## **Access Compliance Report Public Rights-of-Way** (Curb Ramps)

Intersection ID: 52148 Main Street: OLD ARDREY KELL RD Cross Street: ARDREY PLACE DR Location: NW ADA ID: F4F8F585F375 Ramp Type: Perp Initial Pass/Fail: Pass **Overall Compliance: No Severity Score:** 0.25

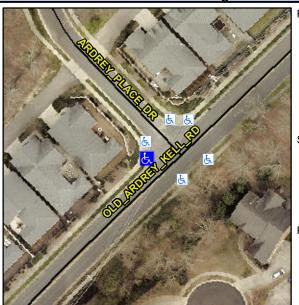
**OLD ARDREY KELL RD** Street 1 Name Stop Condition-Street 2 None Street 2 Name N/A Stop Condition-Street 1 N/A Possible Solutions: Remove & Replace Entire Ramp. Surveyor Notes: N/A PROW/ADA: Not Found, R304.5.3, R304.2.2-Perp, R304.3.2-Para

Field Measurements/Component Compliance						
Compliance Description		Data	Compliance		Description	Data
N/A	Ramp Length (in)	48.0	Yes	Ram	Slope (%)	8.1
Yes	Ramp Width (in)	48.0	No	Ram	XSlope (%)	3.2
N/A	Flare Type LT	Sloped	N/A	Flare Type RT		N/A
N/A	Flare Slope LT (%)	5.5	Yes	Flare	Slope RT (%)	7.4
N/A	Flare Traversable LT?	Yes	N/A	Flare Traversable RT?		Yes
Yes	Landing Length (in)	60.0	Yes	DWS	Provided?	Yes
Yes	Landing Width (in)	48.0	Yes	DWS	Contrast?	Yes
No	Landing Slope (%)	2.2	Yes	DWS	Length (in)	24.5
Yes	Landing X Slope (%)	1.0	Yes	DWS	Full Width?	Yes
N/A	Landing Curb? (Y/N)	No	Yes	DWS	Offset (in)	1.5
N/A	Shared Landing?	No				
Yes	Gutter Ponding?	No	Yes	Gutte	er Slope (%)	0.7
Yes	Gutter Lip Ht (in)	0.0	Yes	Gutte	er X Slope (%)	0.5
N/A	Painted X Walk1?	No	N/A	Paint	ed X Walk2?	N/A
	X Walk 1 Direction	To SE		X Wa	lk 2 Direction	N/A
N/A	X Walk 1 Width (in)	N/A	N/A	X Wa	lk 2 Width (in)	N/A
	X Walk 1 Slope (%)	3.0		X Wa	lk 2 Slope (%)	N/A
